C&I New In-Patient Hospital Tunnel

- LV Schematic cabling supplying MPB-GF-01 Main LV panel from the Transformer/Generator.**

Figure 7-1 – Typical Tunnel Layout, Dimensions and Cable Layout for cables in trefoil

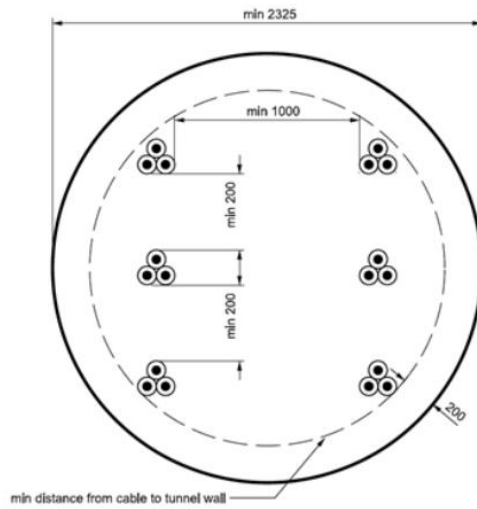
UKPN standard tunnel dimensions below: -

- Alternative option – 2 Nr. Trenches for the 1000kva transformer supply and 750Kva Generator supply cabling to C&I New In-Patient Facility
